Appendix 3: Supporting Technical Reports

Proposed Rural Services Precinct - Transport Review

Prepared for: Selwyn District Council
Job Number: SDC-J050
Issue Date: 19 November 2021
Prepared by: Ashrita Liori, Senior Transportation Planner
Reviewed by: Ann-Marie Head, Associate Director

To	Jon Trewin, Strategy and Policy Planner, Selwyn District Council
Copy	Justine Ashley, Consultant Planner, Selwyn District Council
From	Jeremy Head, Senior Landscape Architect
Office	Christchurch
Date	18 January 2022
File	3-C2413.00
Subject	Proposed Rural Services Precinct overlay to General Rural Zone: Peer review of Applicant's Landscape and Visual Impact Assessment.

Figure 1. The 'islands' site for the proposed Rural Services Precinct overlay is highlighted in yellow. The 'demarcation' between a predominantly industrial and rural landscape character is indicated by the orange line on Marshs Road. ¶

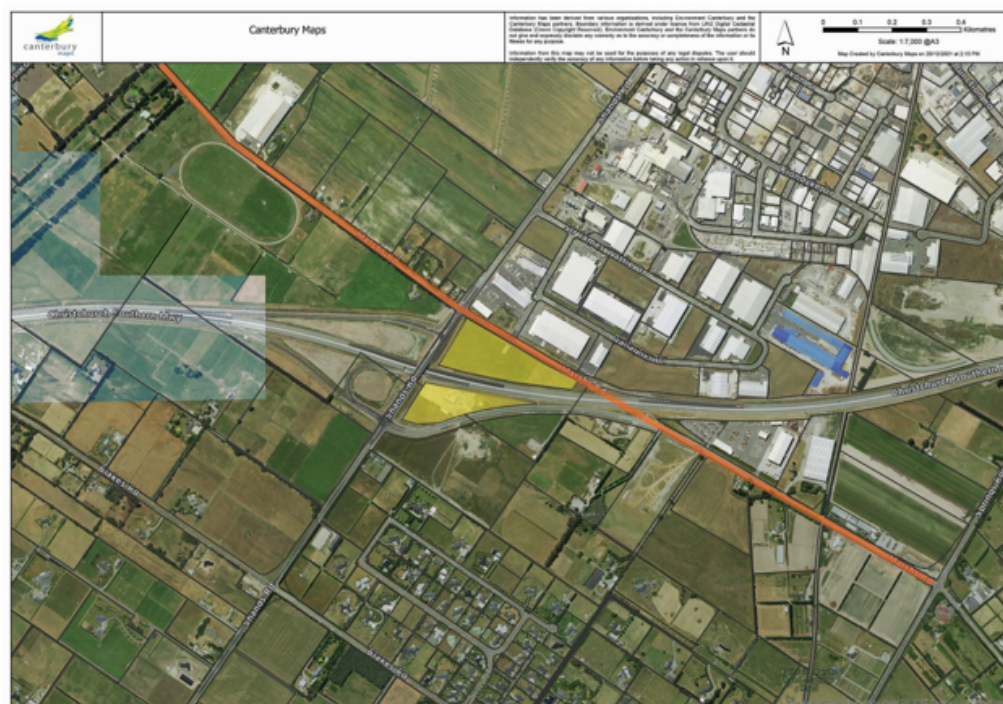
It is the reviewer's opinion that Marshs Road, forms the edge or transition point between Christchurch's heavy industrial zone to the north, and Selwyn District's rural and rural residential area to the south. Though the CSM2 is far busier and broader than Marshs Road, and bisects it, it is not considered to be the 'dividing line', as this feature meanders between rural landuse parcels in other areas to the east and west. The Waste Management facility at 301 Marshs Road referred to in the DCM LVIA as a type of exemplar are on the northern side of Marshs

This means that the 'islands' are within, and therefore more influenced by rural landuse patterns to the south than the industrial ones to the north. As such, the site should ideally be developed to reflect the anticipated outcomes for Selwyn District's General Rural Zone. This will maintain the 'rural belt' of sorts which passes between the Christchurch industrial zone and Prebbleton. If not, and the site was developed

towards a more industrial aesthetic, it could appear as a 'feathering' of the edge of the heavy industrial zone. A 'feathered' edge is less preferable, with development appearing as industrial 'creep'. Contrast between landuse activities is generally preferred, as a contrast accentuates the differences and attributes of each landuse. Marshs Road is a helpful demarcation point in this regard. ¶
